FACILITY: Vogtle, Units 1 and 2

SUBJECT: SUMMARY OF INSTRUMENTATION AND CONTROL SYSTEMS AUDIT HELD  
AUGUST 27-30, 1984

# AUXILIARY FEEDWATER SYSTEM

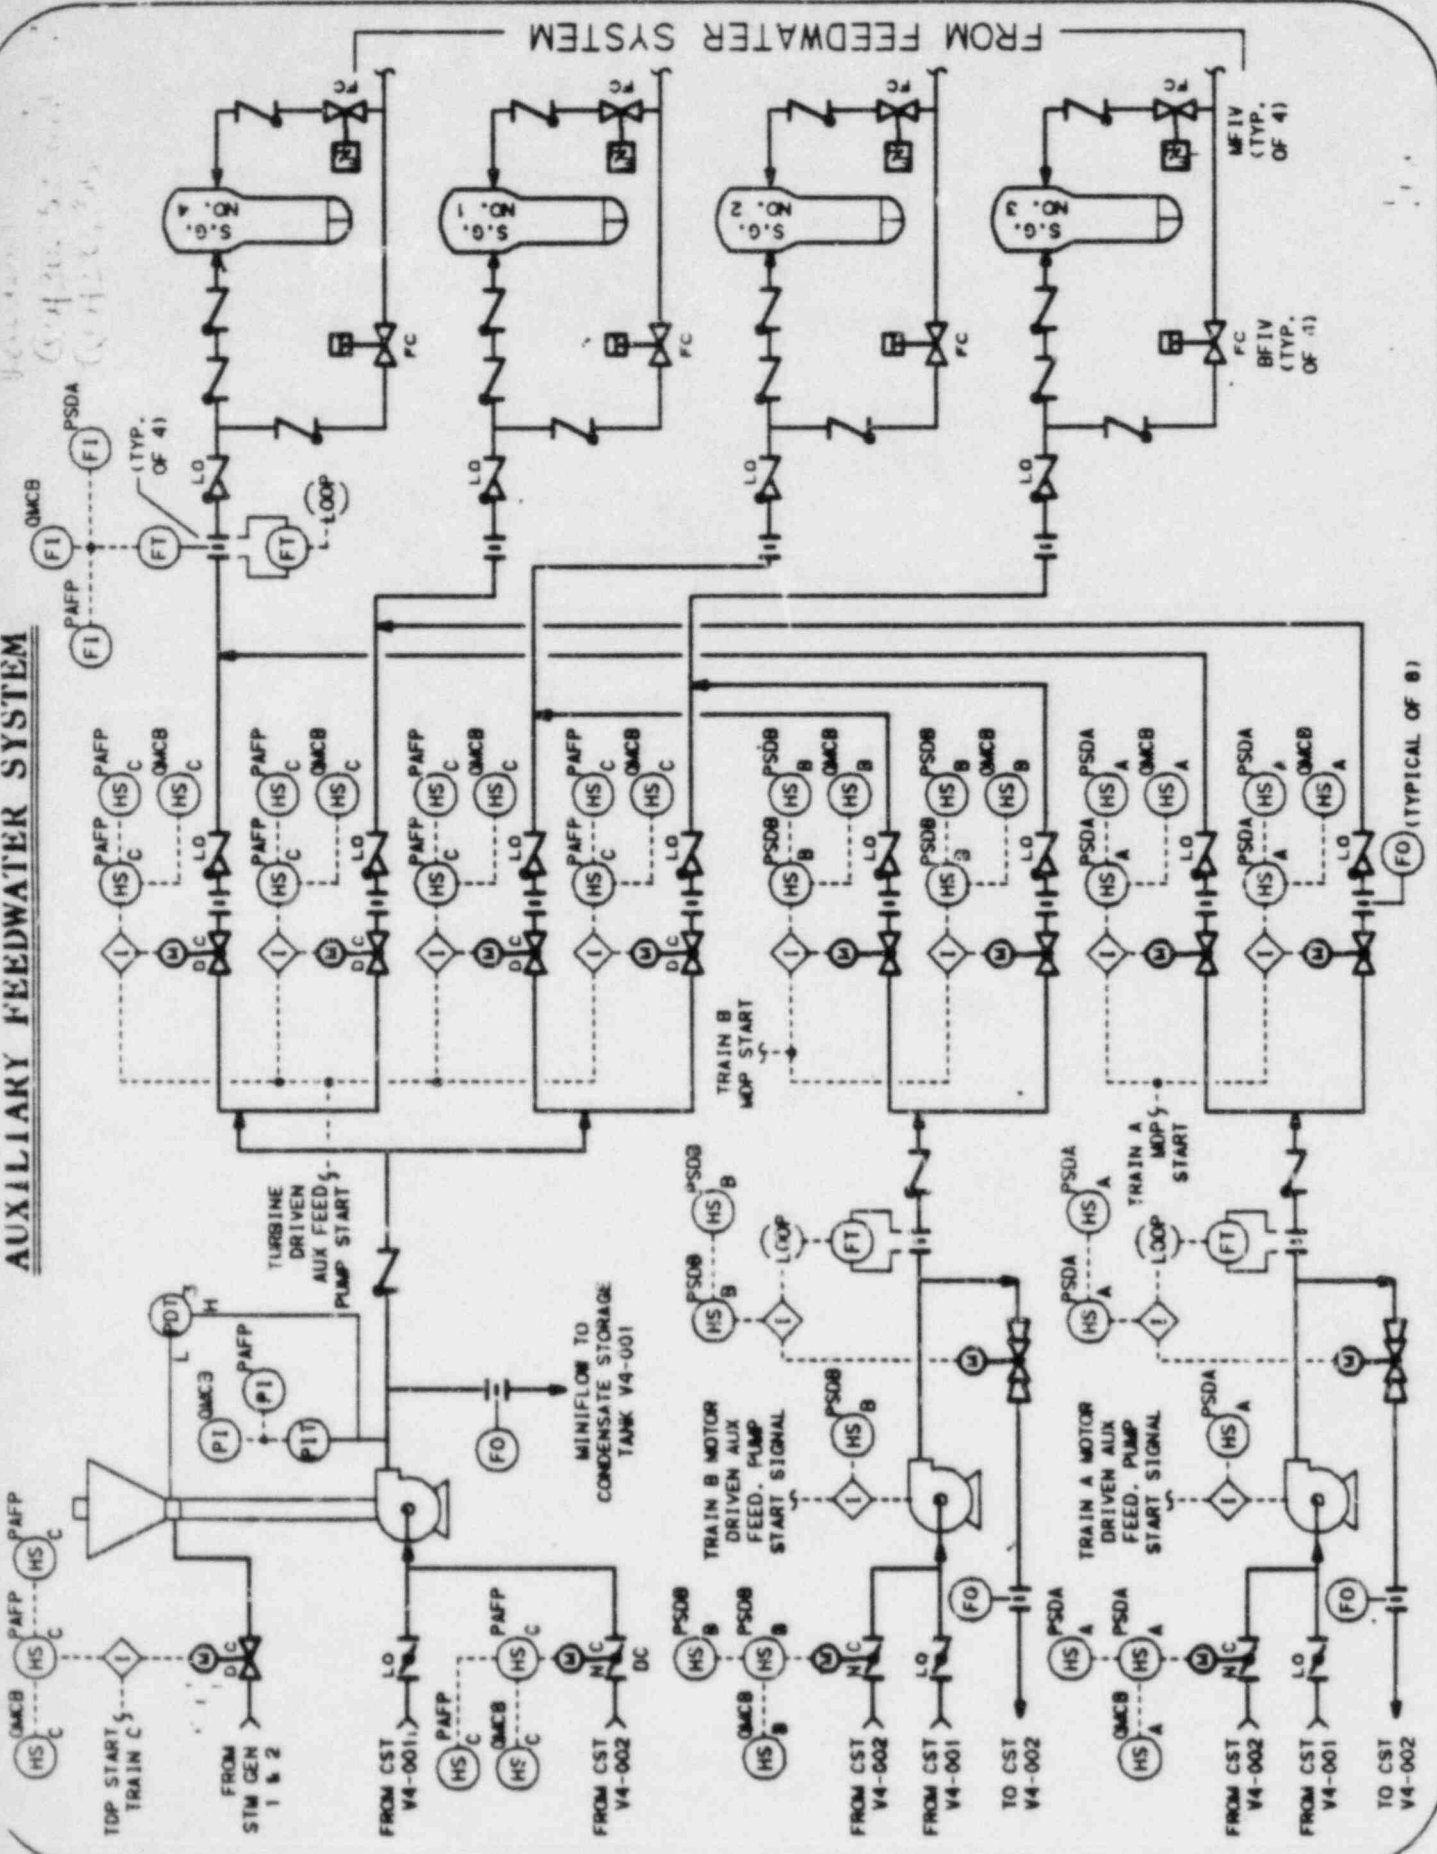
Using detailed system schematics, describe the sequence for automatic initiation, operation, reset, and control of the auxiliary feedwater system. The following should be included in the discussion:

- a) the effects of all switch positions on system operation,
- b) the effects of single power supply failures including the effect of power supply failure on auxiliary feedwater control after automatic initiation circuits have been reset in a post accident sequence.

- c) any bypasses within the system including the means by which it is insured that the bypasses are removed.
- d) initiation and annunciation of any interlocks or automatic isolations that could degrade system capability.

- e) The safety classification and design criteria for any air systems required by the auxiliary feedwater system. This should include the design bases for the capacity of air reservoirs required for system operation.

- f) design features provided to terminate auxiliary feedwater flow to a steam generator affected by either a steam line or feed line break.
- g) system features associated with shutdown from outside the control room.

Using P&IDs and elementary diagrams, the above items a) through g) were reviewed. Georgia Power Company is to provide a commitment regarding testing of the auxiliary feedwater system (item c).

# MAIN STEAM AND FEEDWATER ISOLATION SYSTEM

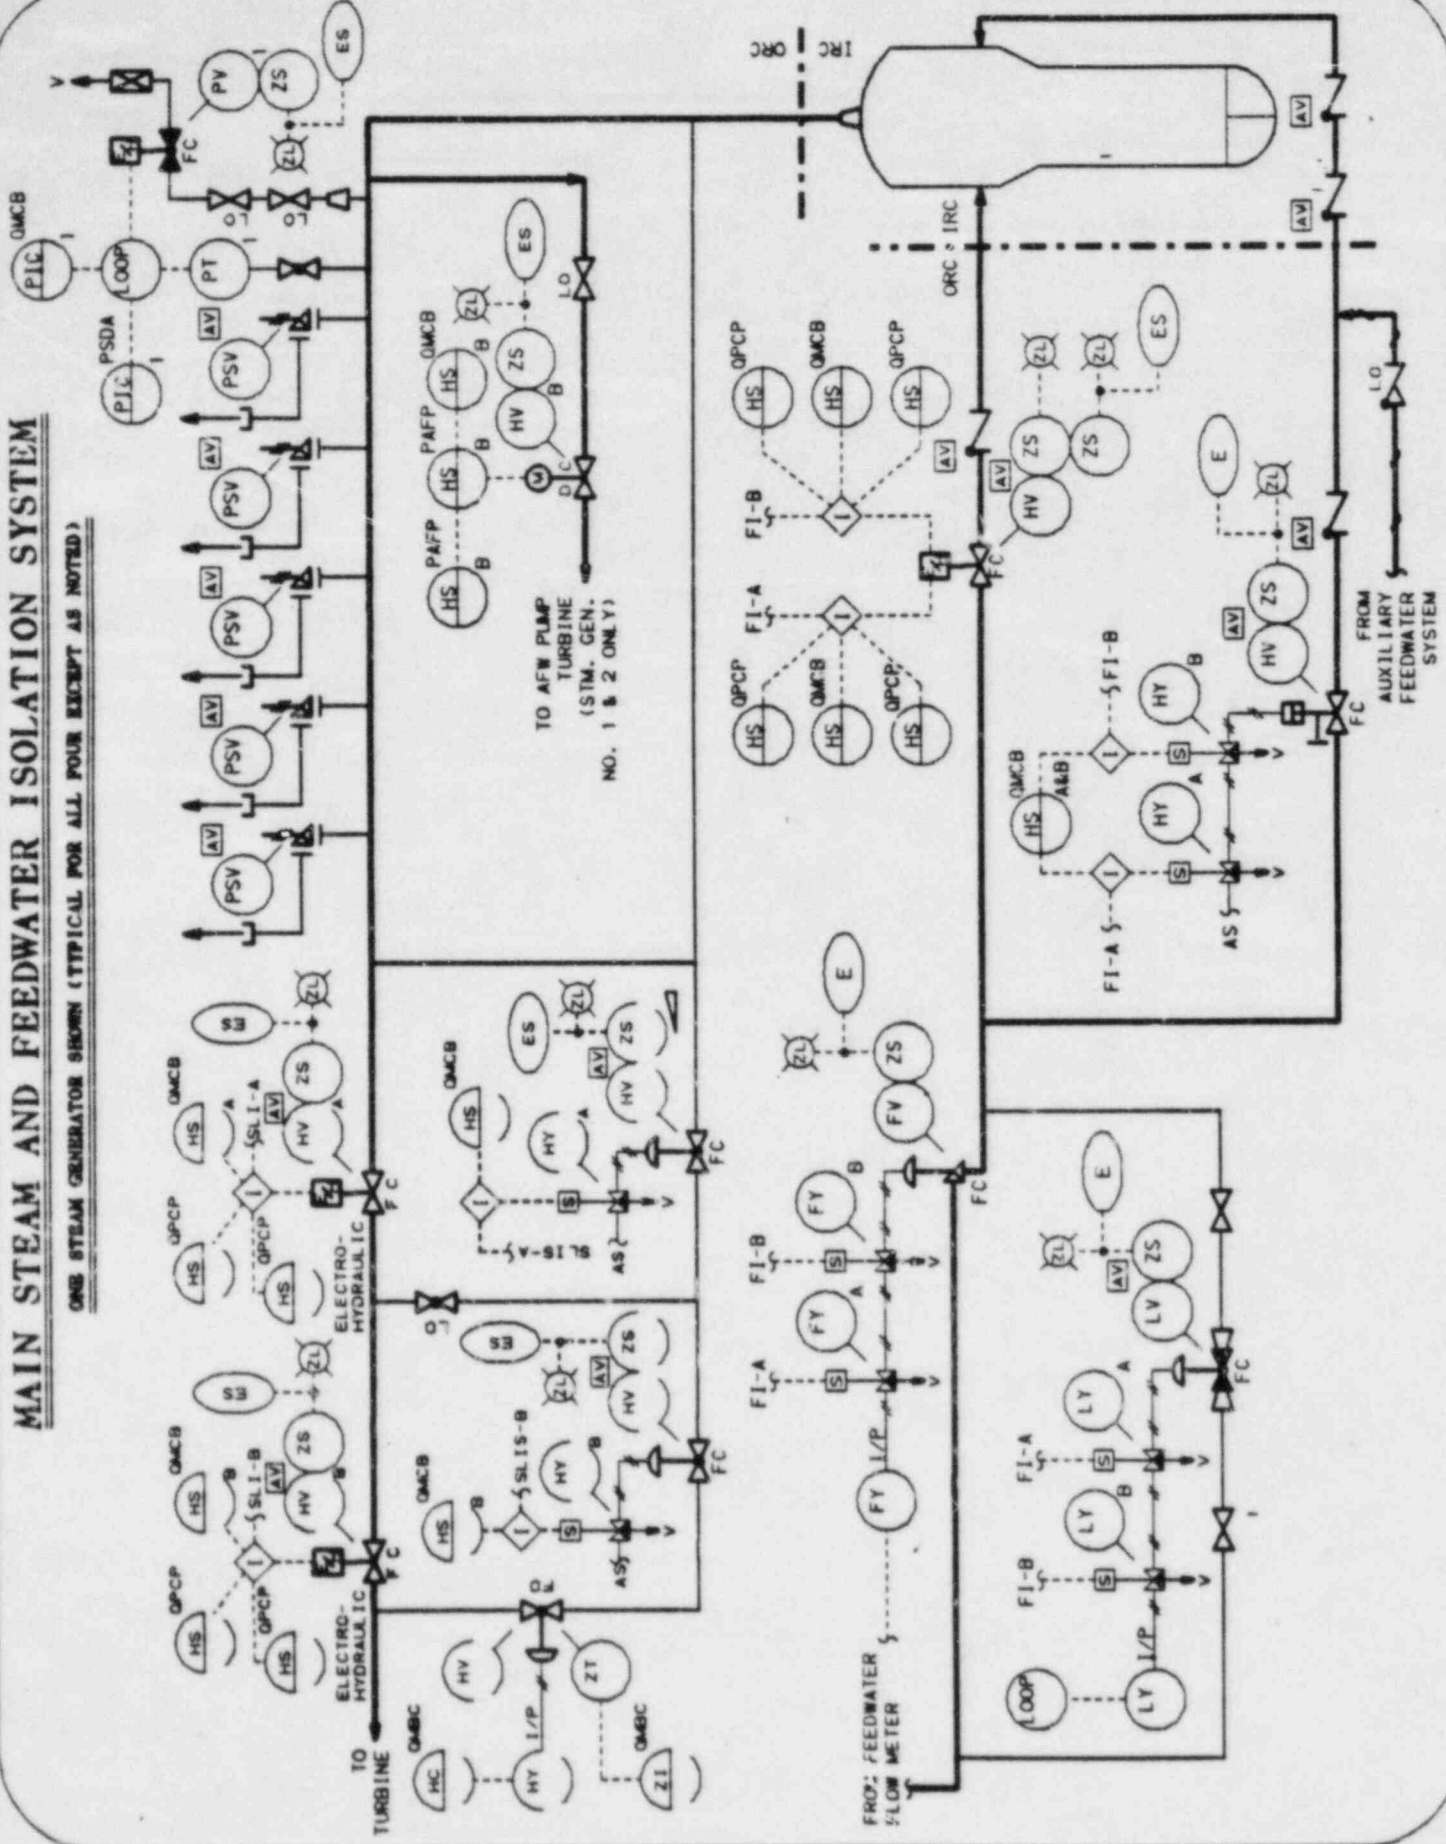
For main steam and feedwater line valve actuation, describe control circuits for isolation valves and include automatic, manual and test features. Indicate whether any valve can be manually operated and indicate specific interfaces with the safety system electrical circuits.

Reviewed main steam and feedwater line valve actuation including electrical wiring diagrams. Automatic, manual and test features were discussed. Interfaces with the safety system electrical circuits were also discussed. Table 7.3.1-2 will be revised to include all actuation signals for feedwater and steam line isolation. Provide justification for no-go testing arrangements which do not check continuity through the final testable actuating device.

# COMPONENT COOLING WATER (CCW) SYSTEM

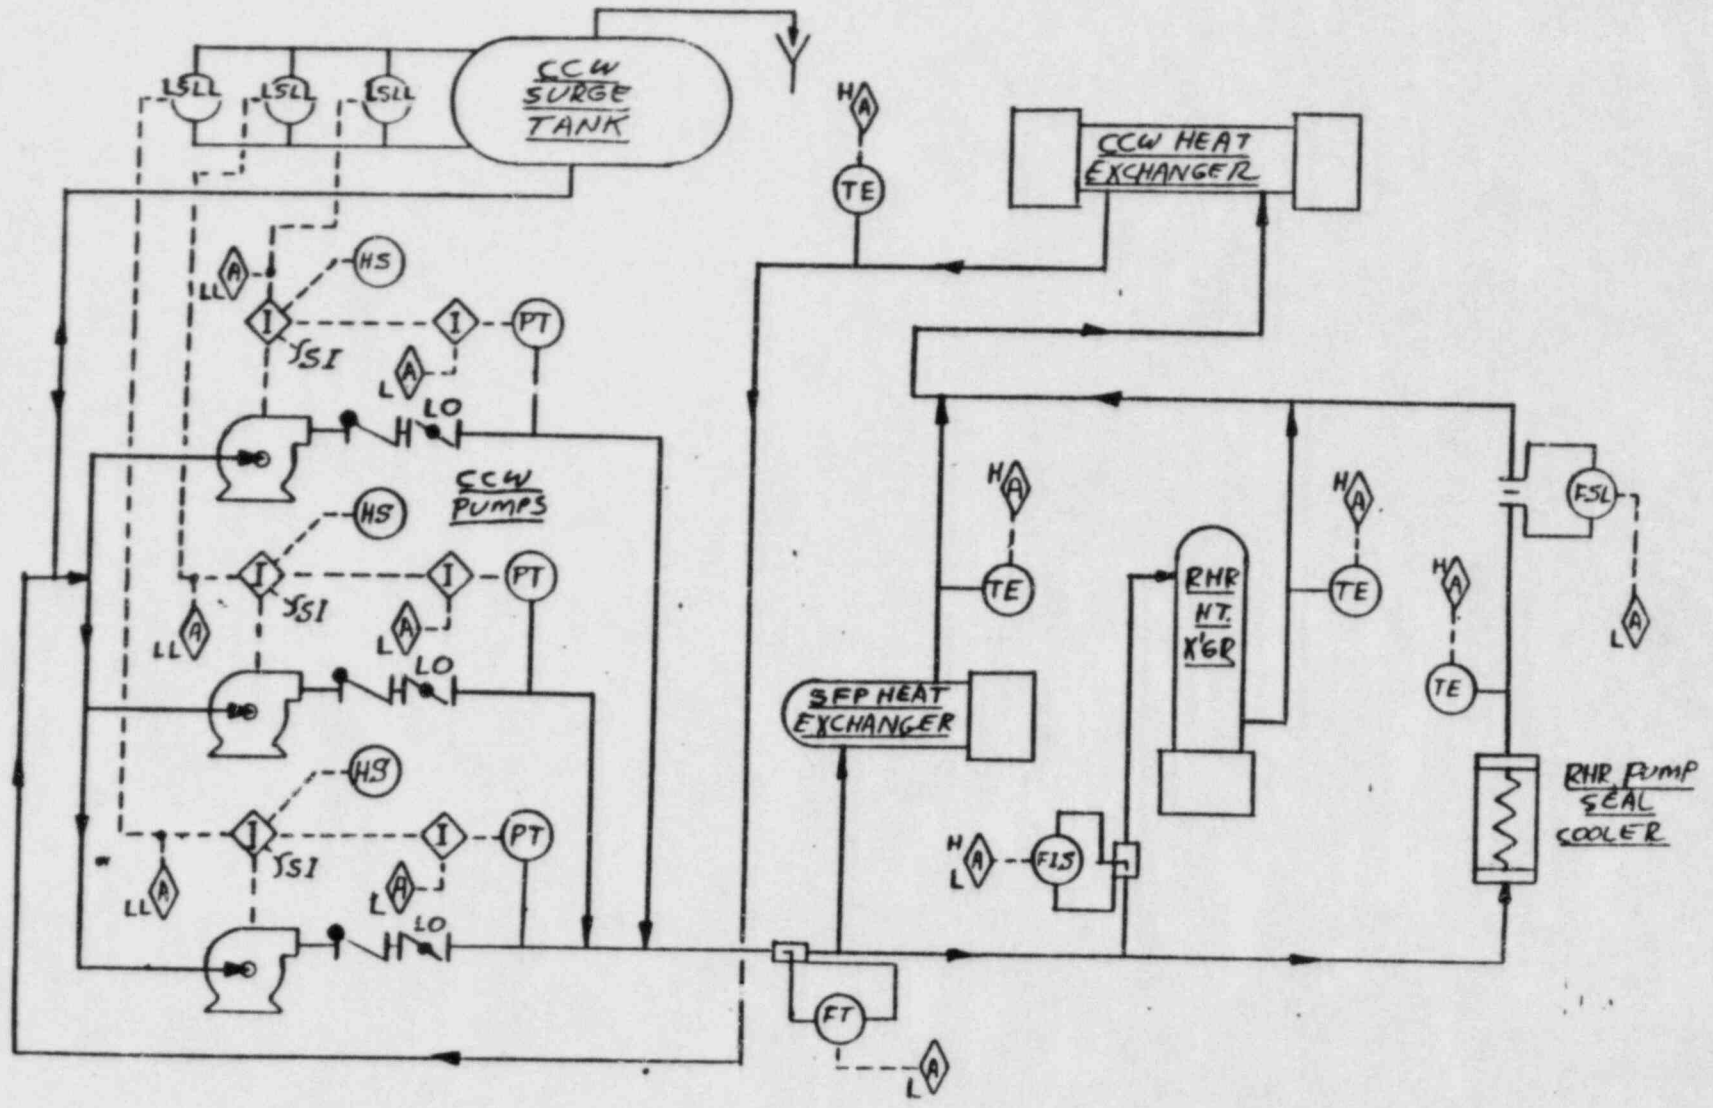
Using detailed electrical schematics and piping diagrams, discuss the automatic and manual operation and control of the station service cooling water system and the component cooling water system. Discuss the interlocks, automatic switchover, testability, single failure, channel independence, indication of operability, and the isolation functions.

With the aid of elementary diagrams and P&IDs, the component cooling water system and nuclear service cooling water system were reviewed including interlocks, automatic switchover, testability, single failure, channel independence, indication of operability, and isolation functions.
